RECALL NOTICE

3730 Anchorage Connector

September 30, 2010

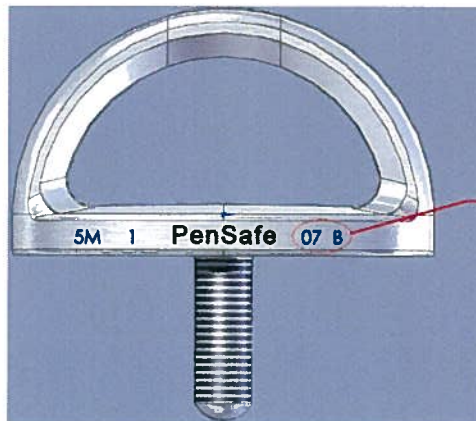
In order to find and remove the defective parts from use, PenSafe is issuing this recall for all 3730 anchorage connectors with manufacturing code "07 B". The diagram below identifies the location of this manufacturing code for positive identification of the suspect product. It will appear to the right of the PenSafe name.
